City of Novi Planning Commission  
45175 Ten Mile Road  
Novi, MI, 48375

June 20, 2018

RE: Lakeview Community Residents  
Response to Robertson Brothers "Lakeview" Project

## LAKEVIEW UNIT COUNT

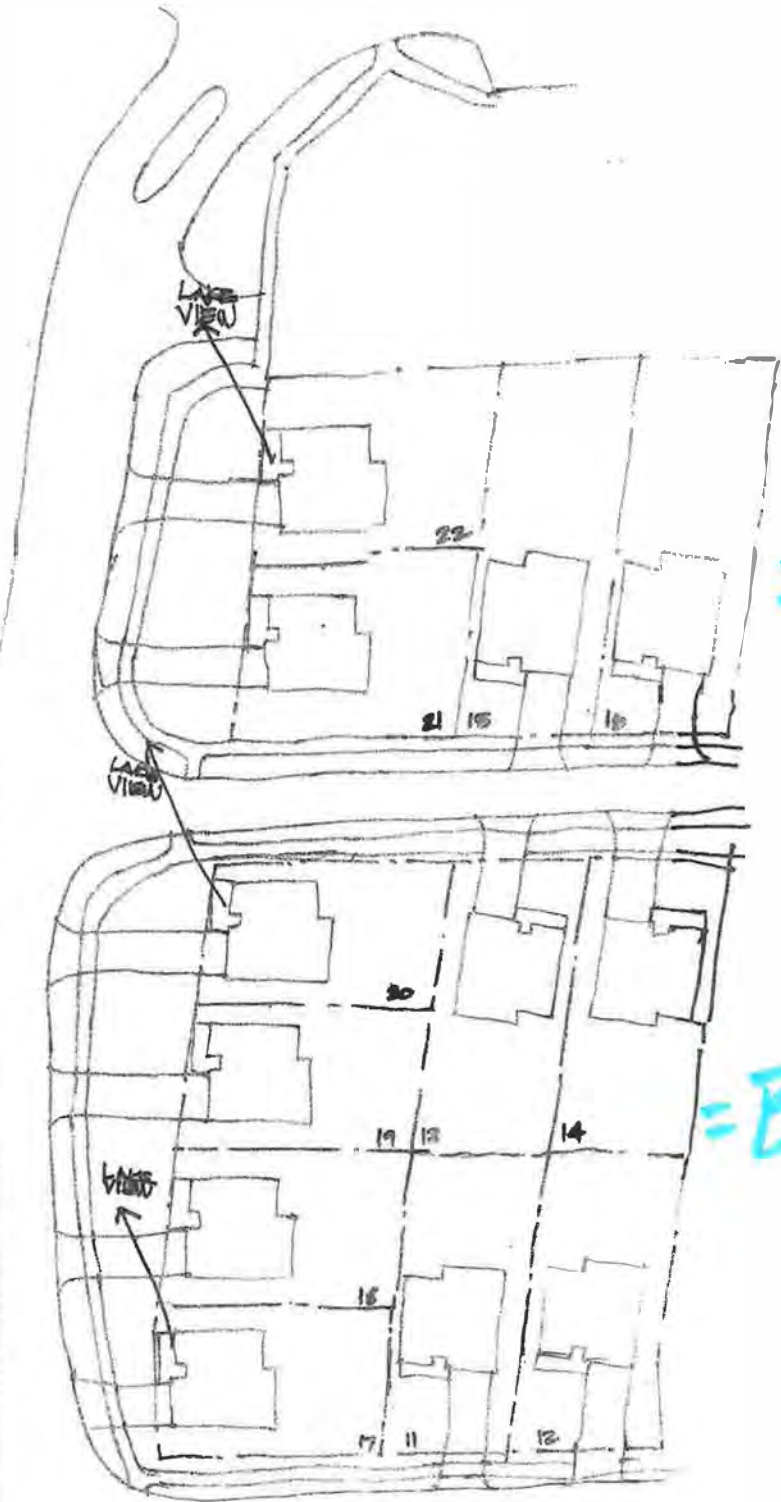
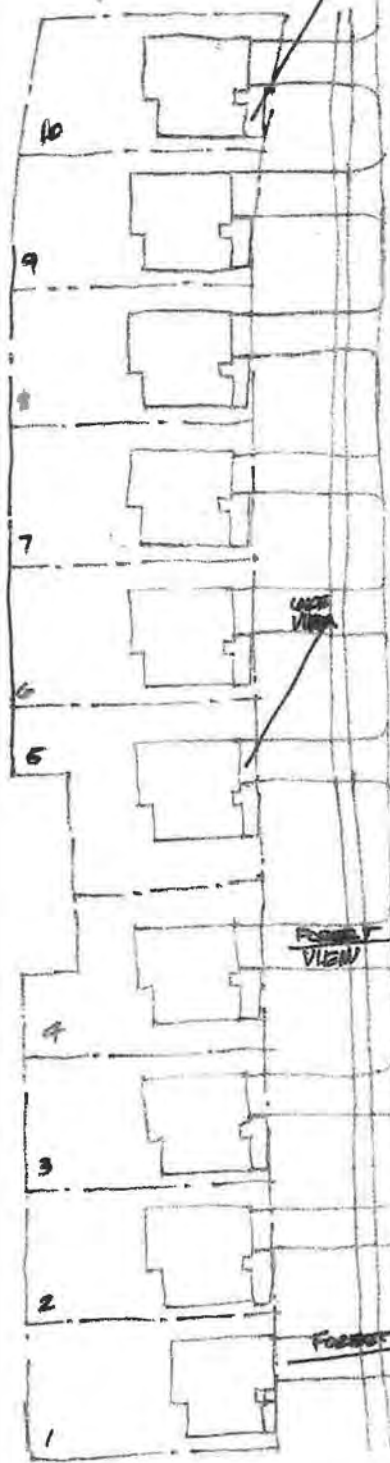
Another sticking point with the community is the unit count. The developer is presenting 31 units. See Lakeview Unit Count chart. The majority of the people would want it to be kept at the 7.3 per acre per parcel specific Parcel A- 9 units, Parcel B -8 units, Parcel C -4 units. If you add up the remaining fractions, 23 units are allowed. Again, the developer wants 31 units with no benefit to the community. Common sense would limit them to 21 or 23 just for traffic. Alternate Plan A allows 22 single family units. Alternate Plan B allows 25 units: 16 single family units and 9 two-story townhomes.

If the Planning Commission wants to keep the unit count at 21, since this is a true to life count, since the parcels are not connected physically, we recommend Parcel A loses 1 unit to nine homes from the Alternate Plan A. Again, this project presents no benefit to the City.

If the Planning Commission wants to keep the unit count to 23, we recommend Parcel A loses 1 unit to nine homes from the Alternate Plan B. We also recommend, Parcel C have a duplex versus a triplex. This gives us a unit count of 23, again this project presents no benefit to the City.

ROBERTSON'S  
VISION

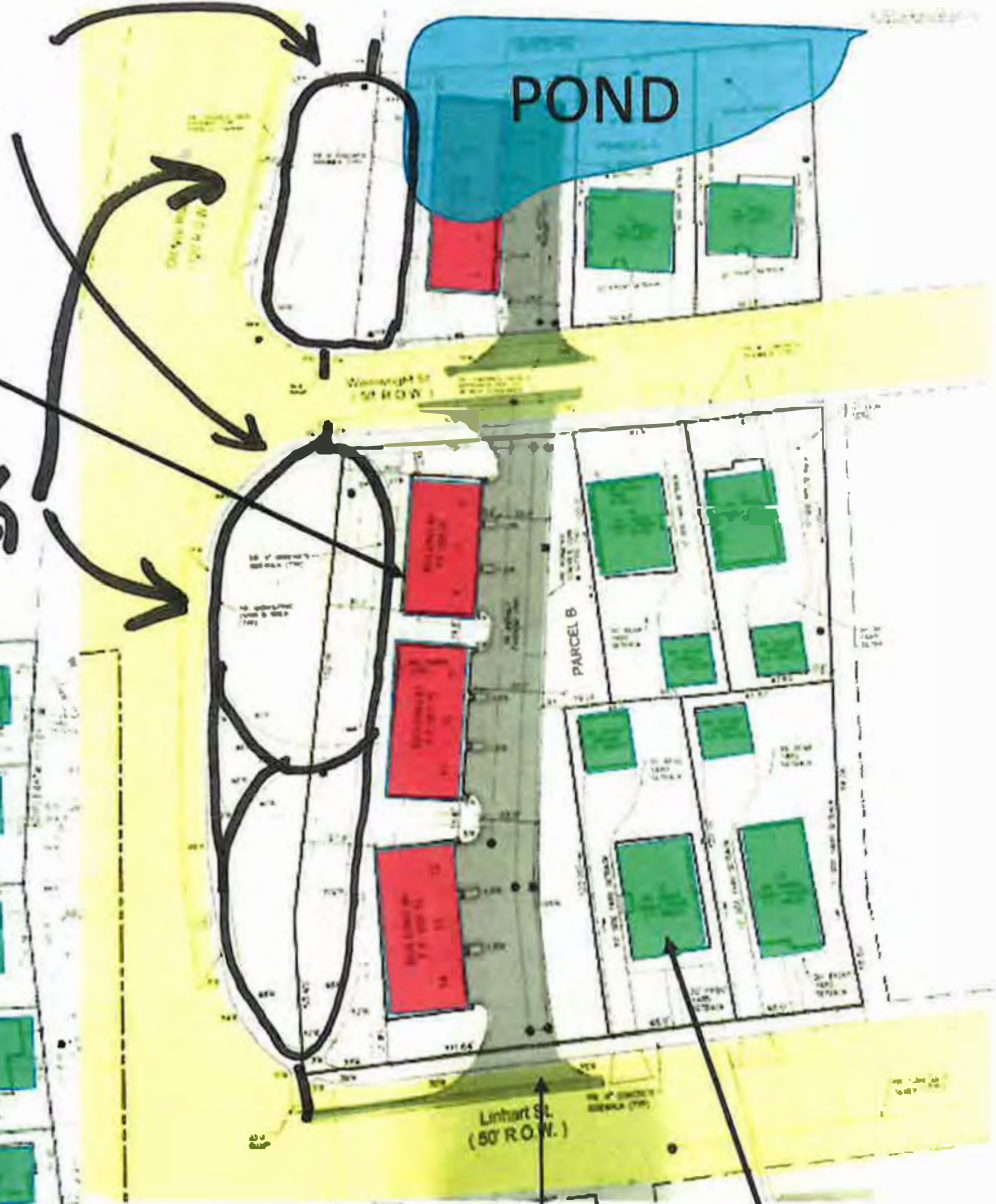
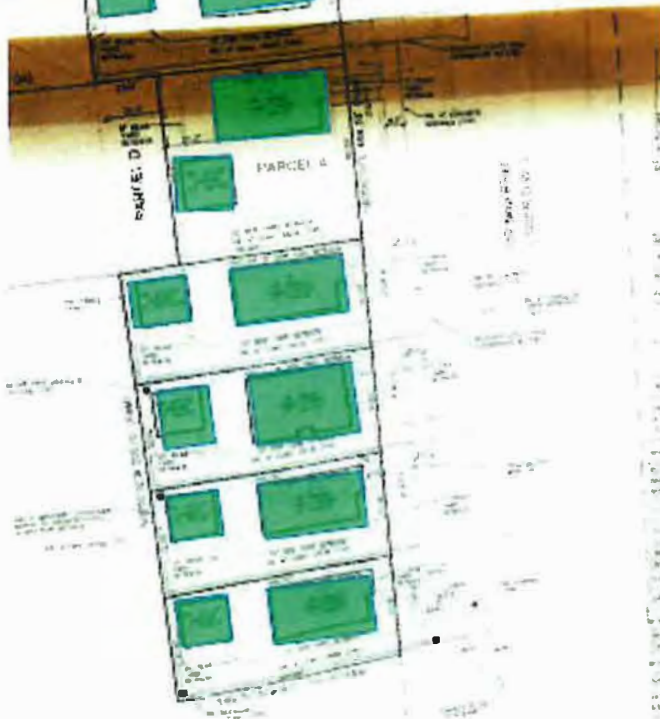
SIDE WALKS  
TO NOWHERE

3 Story  
Apartment  
Homes

STREET PARKING  
DN OLD HOVI RD

Exit on Side  
street???

THE LAKEVIEW

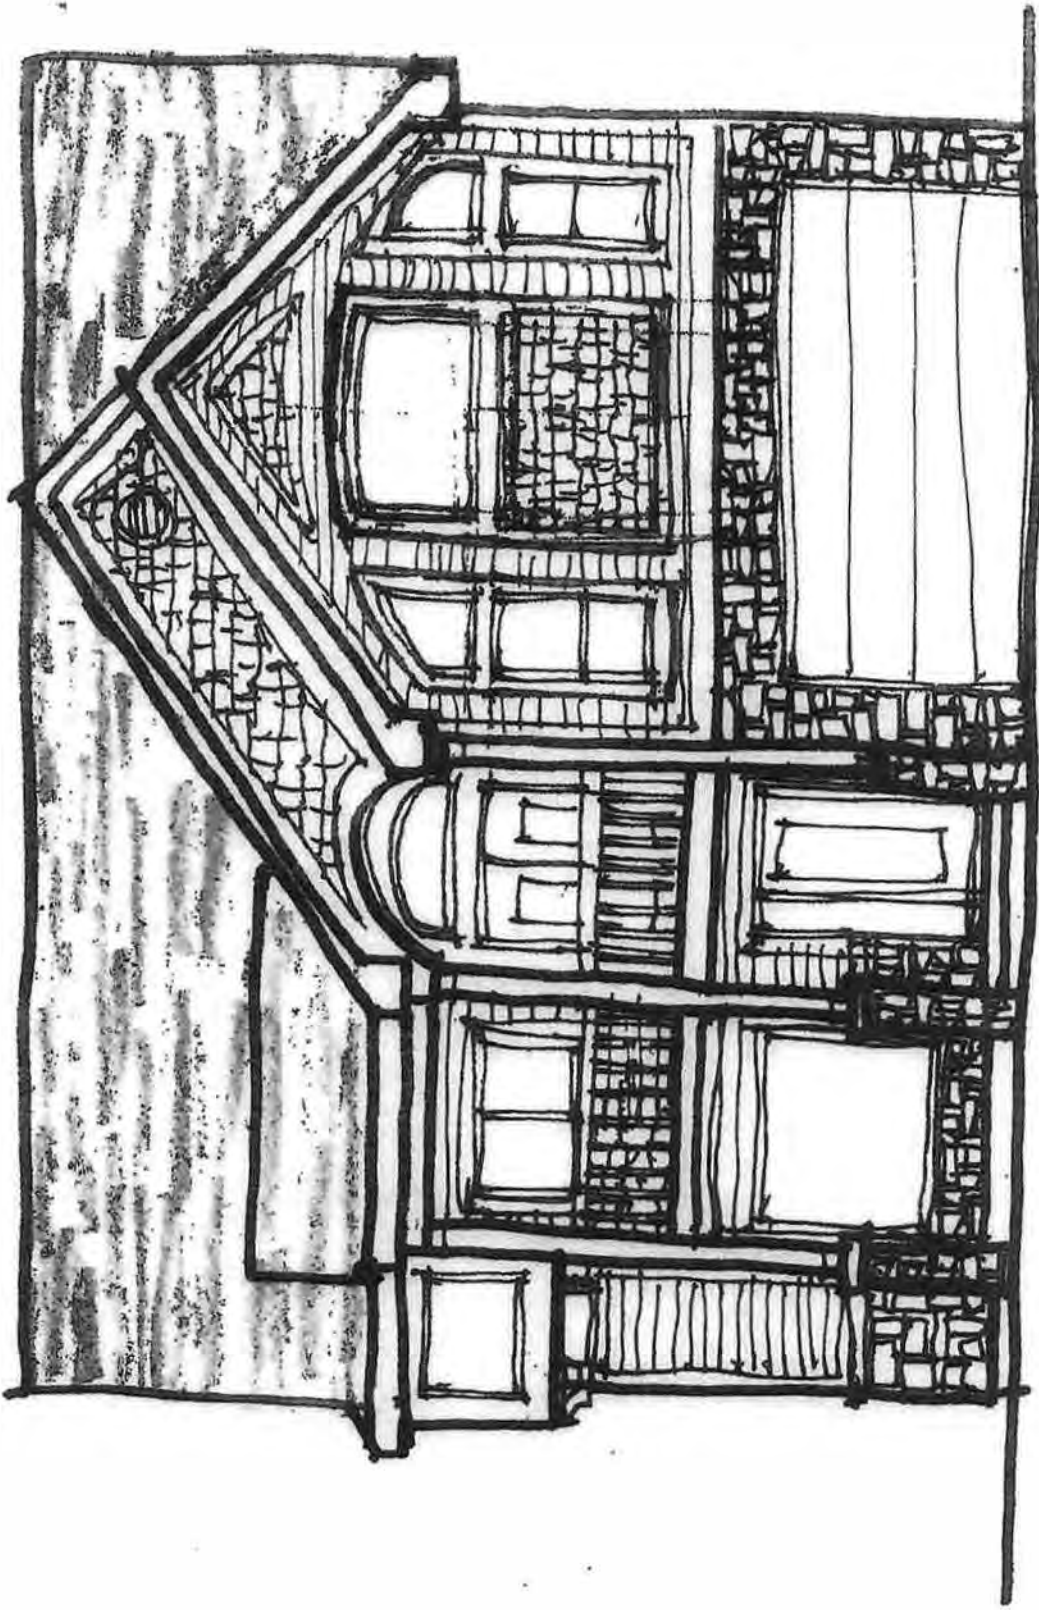
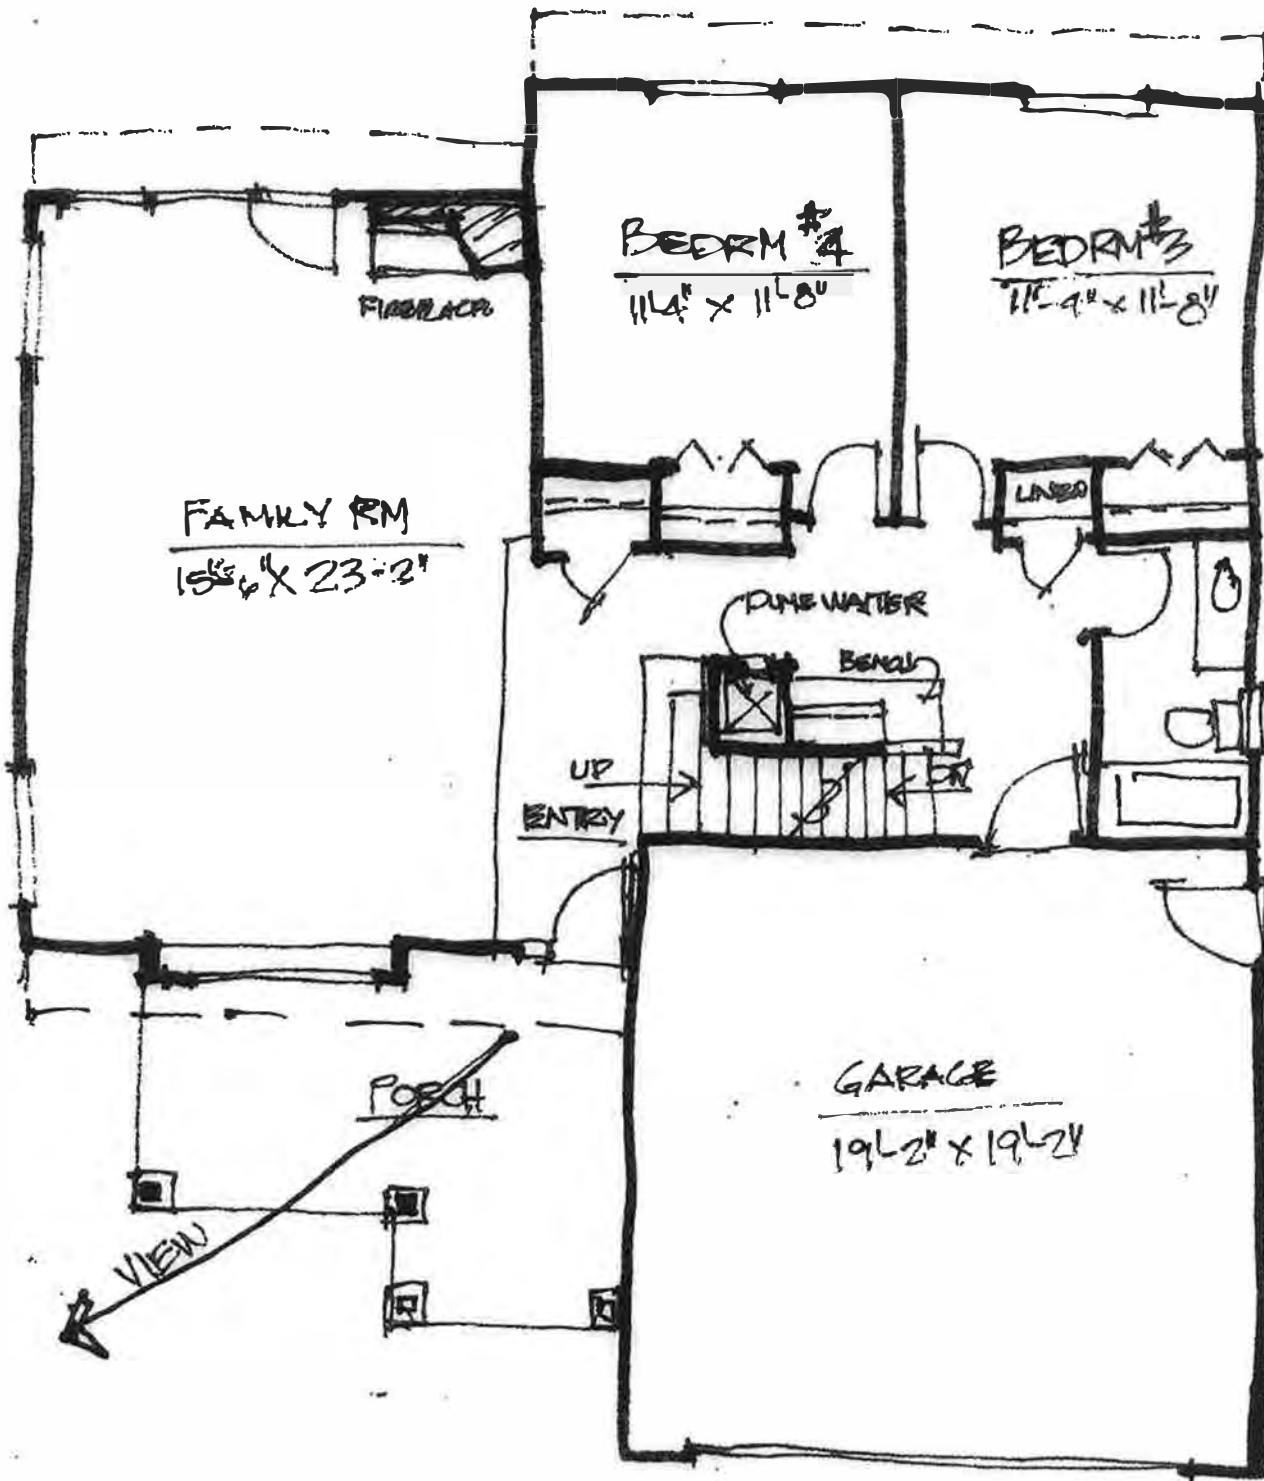
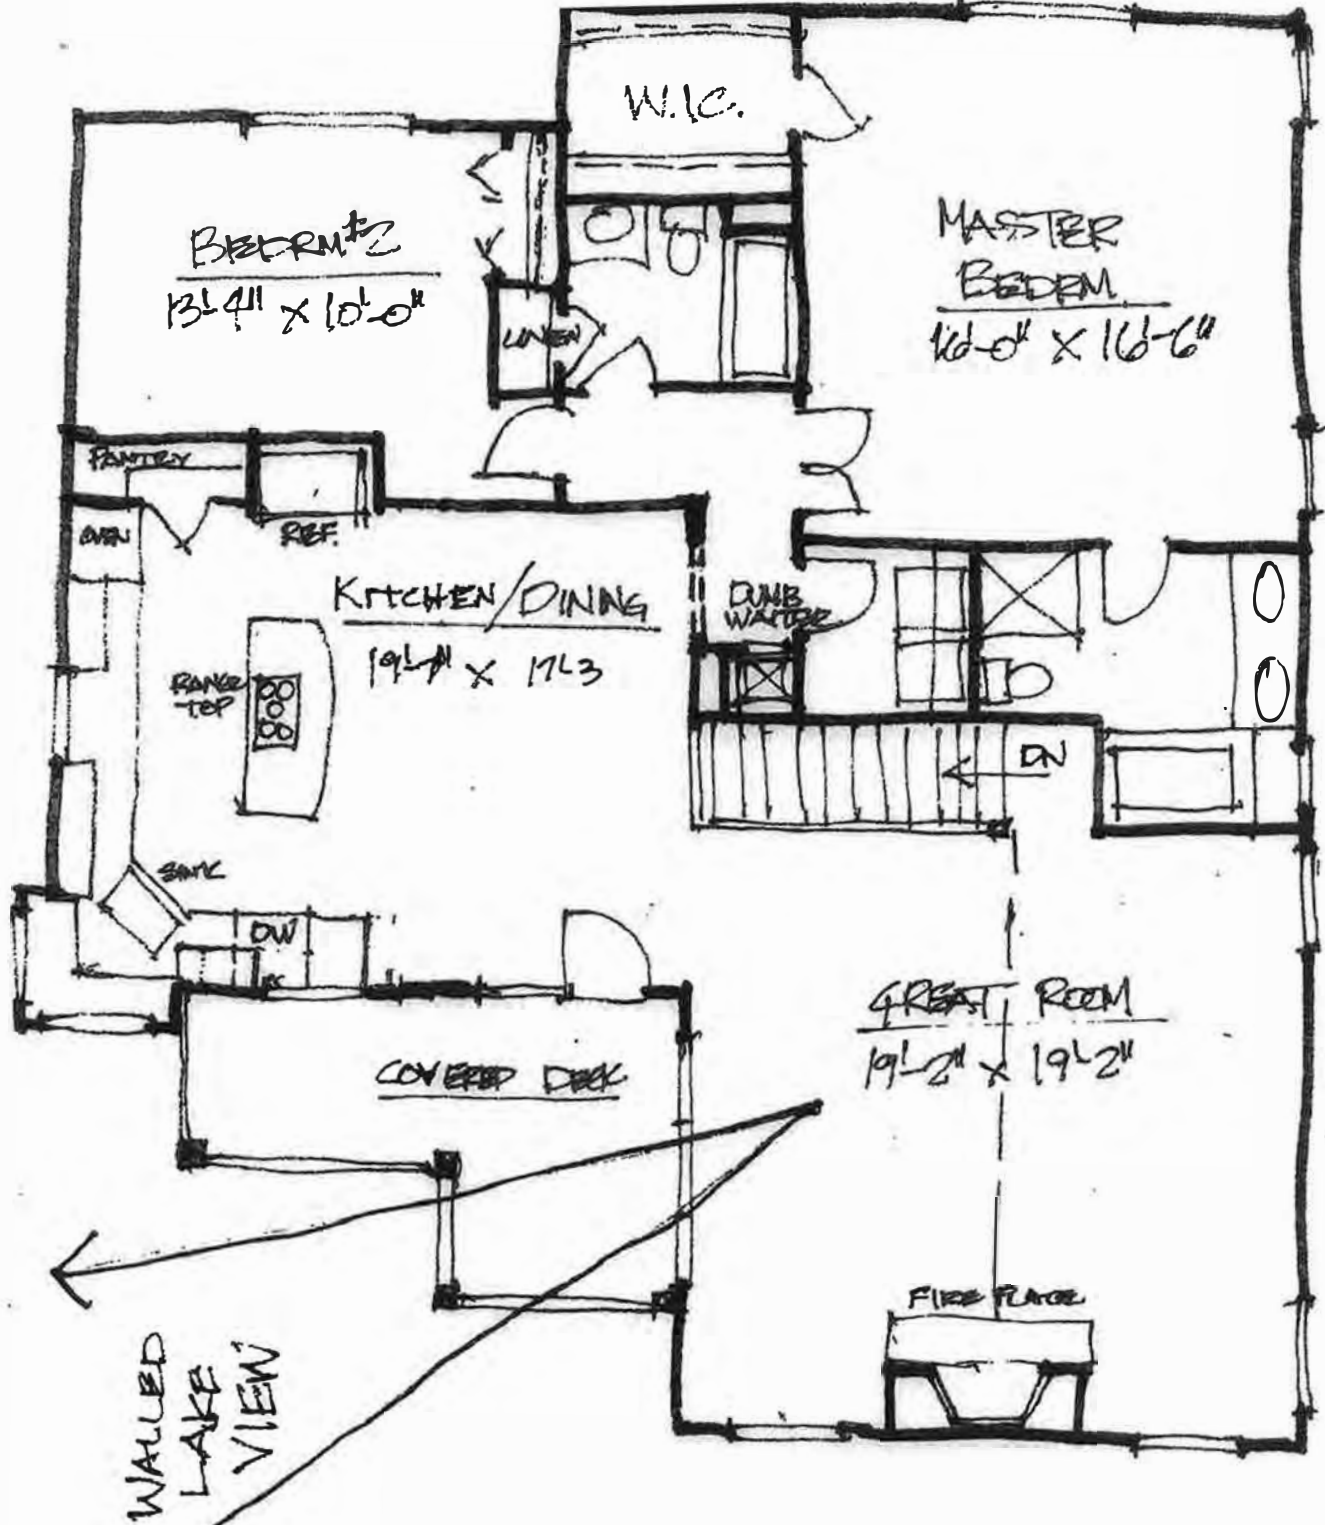
The Developer and the Community would be short sighted In their thinking by not allowing more to happen! Old Novi Road has the ability to extend Pavilion Park down the street with the 120 feet right- of-way. This requires residential units to be designed and oriented toward the park and water. If the homes are designed with orientation and front porches and decks, room views toward the water, such outdoor spaces may be enticed to be used. It is a lakeview culture and the front porch (prior to electronics) was a way of strengthening community and socialization.

Please see the attached single family home designed called "The Lakeview" as an example what could be developed for the property.
